# UNITED STATES PATENT AND TRADEMARK OFFICE

APPLICATION NO.	FILING DATE	FIRST NAMED INVENTOR	ATTORNEY DOCKET NO.	CONFIRMATION NO.
10/826,990	04/19/2004	Bryan M. Buchi	3053.2.1	3498

<b>Office Action Summary</b>	<b>Application No.</b> 10/826,990	<b>Applicant(s)</b> BUCHI, BRYAN M.	
	<b>Examiner</b> Paul Devoti	<b>Art Unit</b> 3637

Bryant et al. (US 2004/0035063) Figure 2

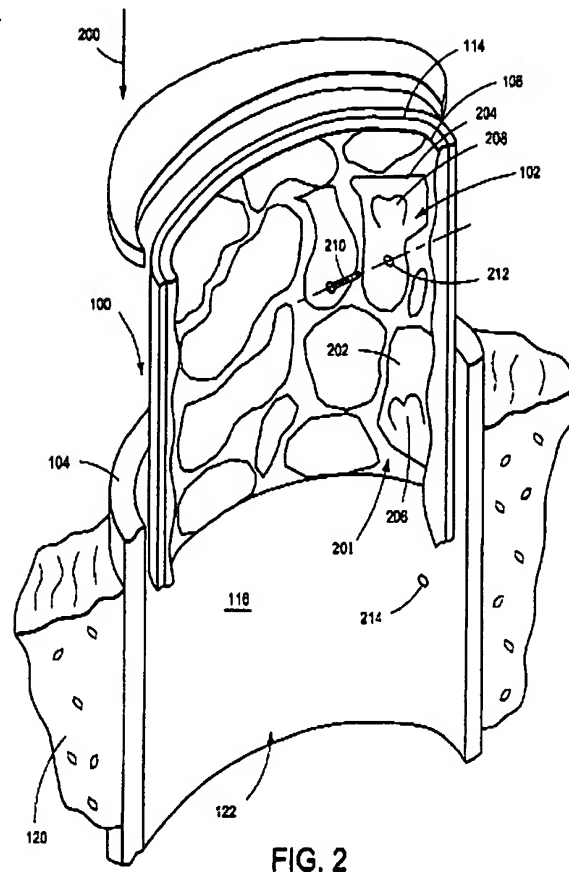
12. Claims 1, 2, 5, and 6 are rejected under 35 U.S.C. 102(e) as being anticipated by Bryant et al. (US 2004/0035063).
13. Regarding claim 1, Bryant discloses a window well shield assembly (100) including a window well (104) and a shield (102). The window well shield (102) has a first side (106) with a three dimensional pattern (108) that protrudes therefrom, and a second side (114) capable of contacting and attaching to a window well (104).
14. Regarding claim 2, the first side (106) comprises a pattern of artificial rocks (108).
15. Regarding claims 5 and 6, the window well shield (102) is secured to a window well (104), with screws (210) that pass through the liner (106, 114) and into the window well (104).

McGinnis (US 4896467) Figure 1

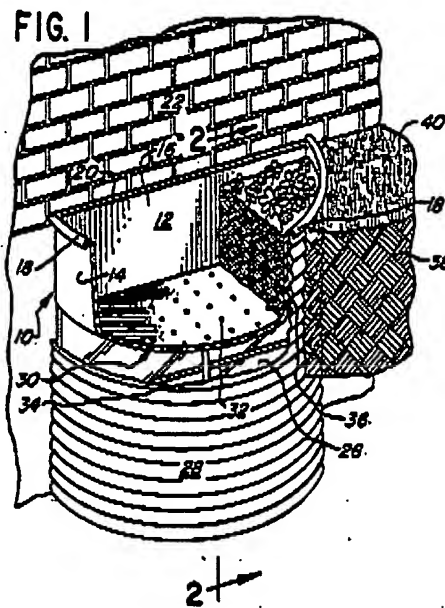
18. Bryant discloses everything previously mentioned, but does not disclose a cap engaging the top edge of the window well shield (102) and top edge of the window well (104). McGinnis, however, discloses a window well cover with a cap (18) that engages the top of the well cover (14) and the top edge of the window well (28). Therefore, it would have been obvious to one having ordinary skill in the art at the time of invention to modify Bryant's window well shield to include a cap that engages the window well shield and the window well, as taught by McGinnis to secure the covering to the window well.

Rygiel (US 6237294) Figure 3

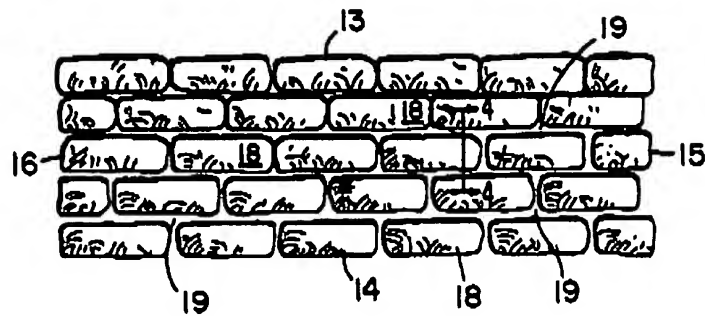
28. Regarding claim 10, Bryant in view of McGinnis discloses everything previously mentioned, but does not disclose that the pattern is a series of generally rectangular shaped rocks. Rygiel, however, discloses a decorative panel (10) with rectangular shaped bricks (18). Therefore, it would have been obvious to one having ordinary skill in the art at the time of invention to modify Bryant's window well shield, already modified by McGinnis, to include a pattern with rectangular shaped rocks, as taught by Rygiel to have a molded panel with a desired pattern.
